COUNCIL ASSESSMENT REPORT

| DA Number | DA-245/2017 |
| Proposed Development | Demolition of buildings and the construction of a 19 storey mixed use building with basement parking |
| Street Address | 552-568 Oxford Street, Bondi Junction |

Figure 5: Red area highlighting the extent of the height non-compliance.

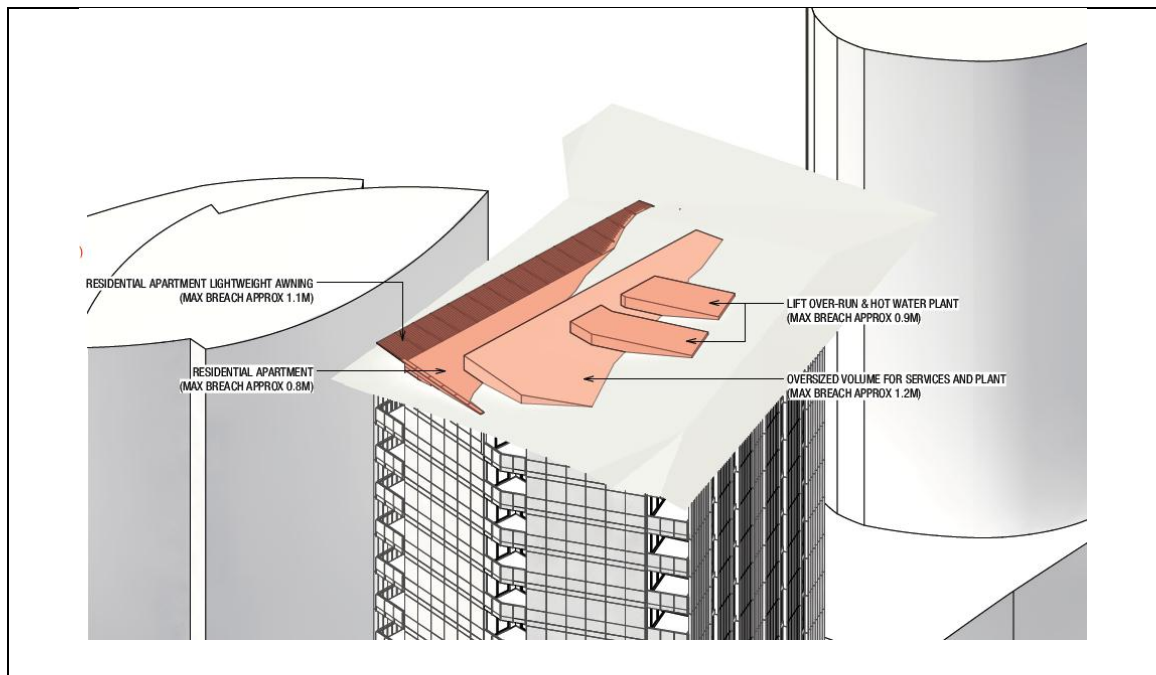
The applicant's diagram below demonstrates the extent of the height non-compliance, as described in the Clause 4.6 submission. It is agreed that the height variation will not be visually obvious from the public domain, and would not result in the building appearing out of context with the other recently approved buildings in the vicinity with the same height restriction.

It is argued by the applicant that the height non-compliance occurs to the nature of the slope and given this predominantly occurs to the northern side of the building closest to the lane, the amenity impacts that result are acceptable.

It is agreed the non-compliance which predominantly relates to the northern side of the building to the rear would not have a significant impact to the streetscape, as the more dominant corner to Adelaide Street and Oxford Street frontage complies with the 60m height limit. Similarly, the lift overrun and plant room being located within the middle of the tower form will not be visually obvious from the public domain and is similar to other high density buildings in the area. It will be visible from other buildings within the vicinity, however this is inevitable in a dense town centre where impacts between the buildings is reciprocal. It is accepted that the plant room and lift overrun will have negligible overshadowing impacts being located in the middle of the tower.

Figure 6: Calculable GFA in ground and lower ground levels.

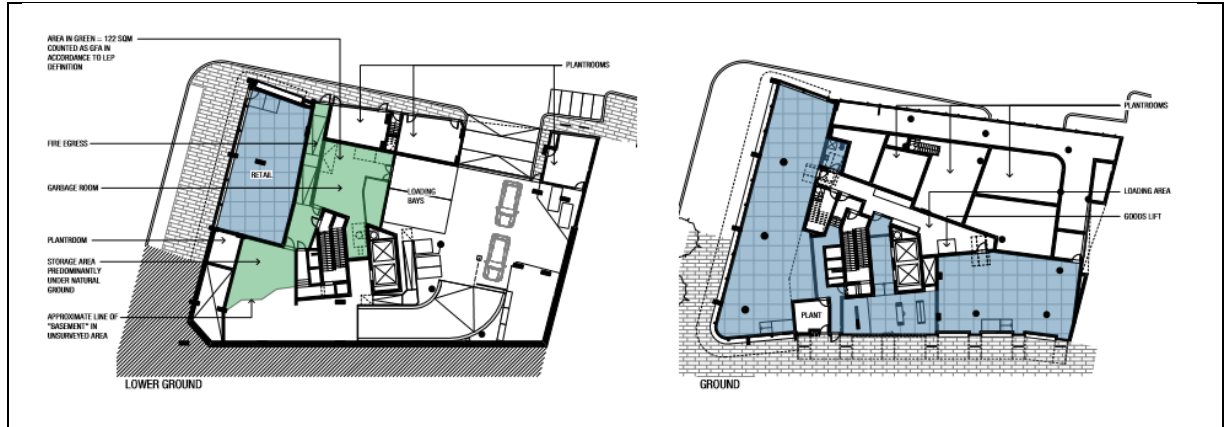
The diagram below shows the lower ground and ground levels, the blue indicating the calculable GFA and the green indicating the additional floor area included in the GFA calculations on the account of it being located above ground.

Council has an issue with the amount of calculable floor space in the podium levels. As seen from the plans above, a large percentage of these floor plates, are void of calculable floor space, instead filling the tower form with more floor space resulting in poor separation between buildings and a wider tower than anticipated by the urban design controls in the DCP.

All plant and storage space should be located in basement levels, allowing for commercial floor space on the ground and lower ground floors.

Figure 8: Extract from Part E1, Clause 1.8

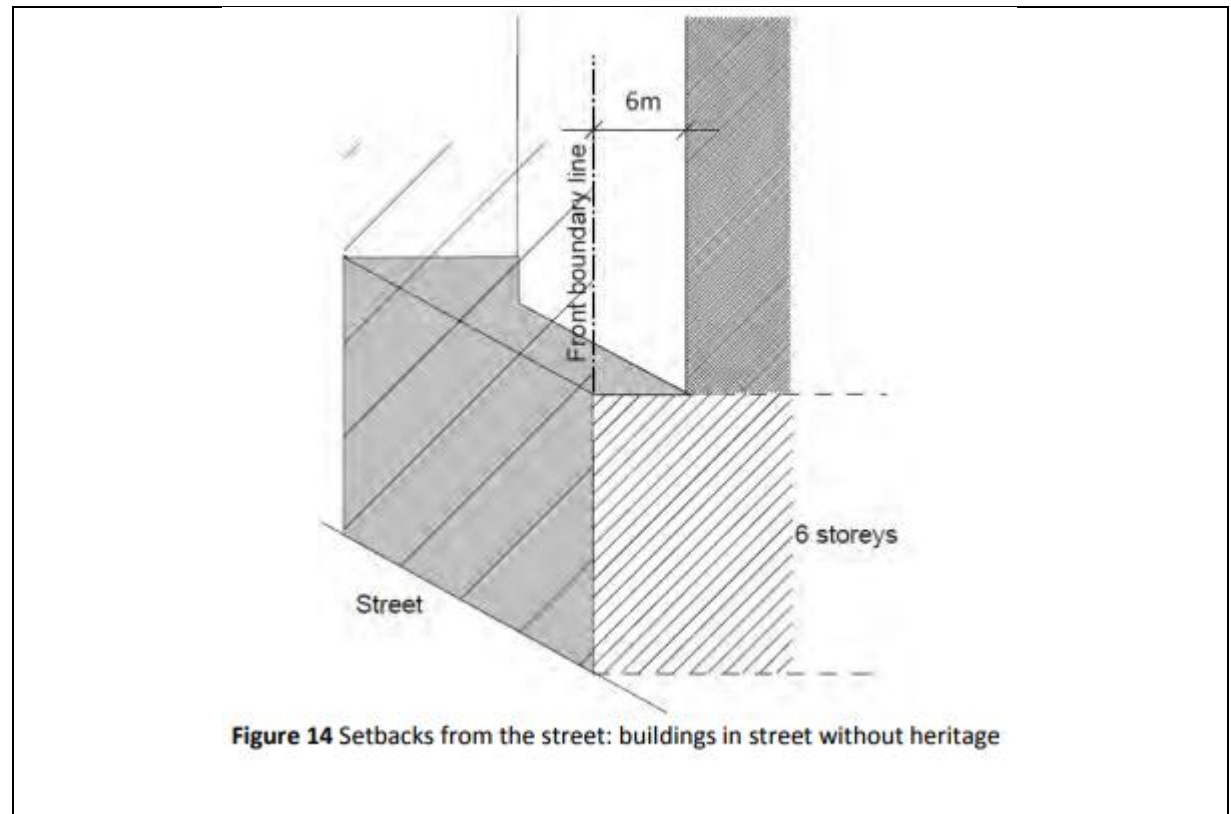
The Urban Form Controls in Part E1 of the DCP require the street wall/podium to be 6 storeys with a tower form setback from the street edge of 6m. An extract which demonstrates the desired building form is below.

It is recognised that a 6m setback between the tower and podium may be difficult given the constraints of the site, however a setback which provides a clear separation should be provided to achieve the objectives of the controls.

Figure 9: Distance separation, demonstrated by the southern elevation/Oxford Street elevation

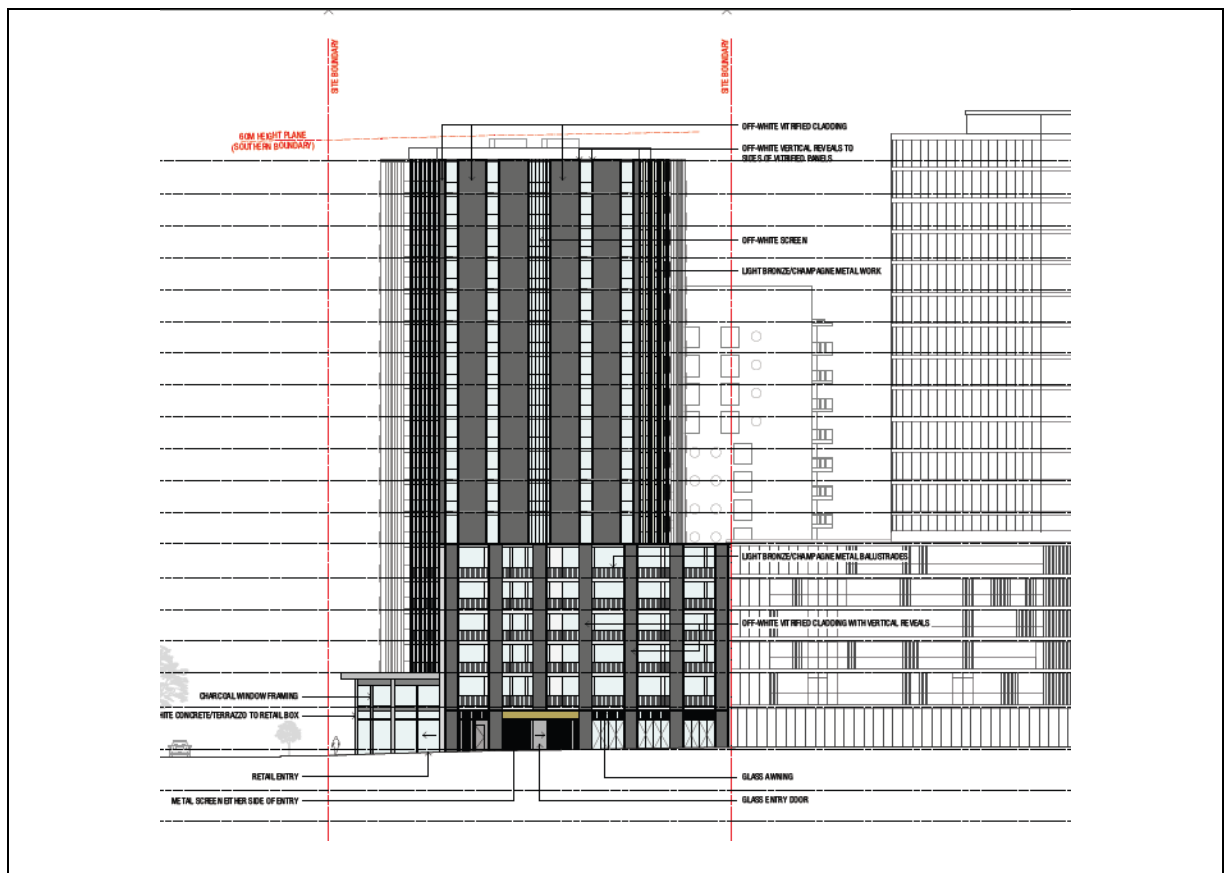
The proposal however does not adequately provide equitable distance separation to the adjoining building to the west, the Vue, with the distance between the two tower forms nominated as 20.5m,

with less than half that distance provided by the subject development with the tower form set 7m from the common boundary, as shown in the figure below. The distance between the two should be equitable.

The lack of separation between the adjoining eastern building at 570 Oxford Street and failure to provide a setback to the podium below illustrates that the tower form is disproportionate to the podium, contrary to CCP control 1.2 (c) which requires tower forms to be slender.

Figure 10: Outlook from top level of 'The Aqua' building at 241 Oxford Street, Bondi Junction

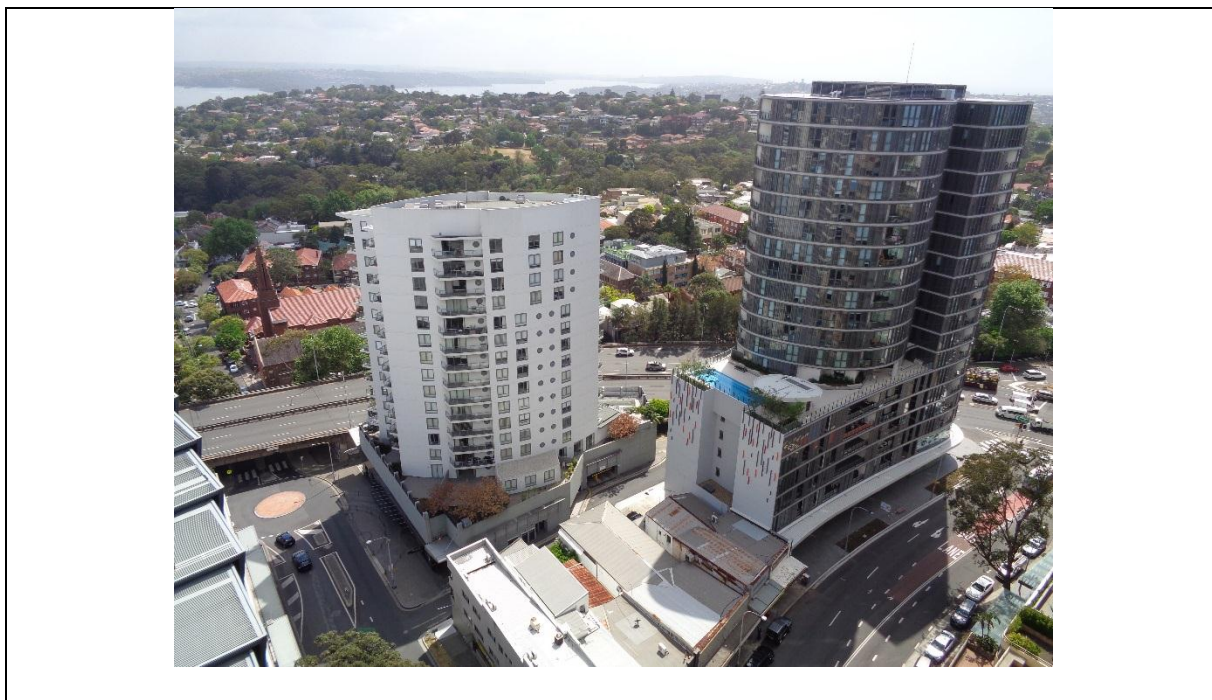
It is clear from inspecting the visual impact from units within adjoining properties, that providing a more slender tower would not only have benefits to provide visual privacy, but also break up the visual massing between large tower forms and facilitate view sharing. Below is a photo taken from a unit within 241 Oxford Street which demonstrates that the proposed tower form will enclose the gaps currently provided between the 'Eclipse' development (white building) and 'The Vue' building at 570 Oxford Street which currently provides views to Sydney Harbour and Manly.
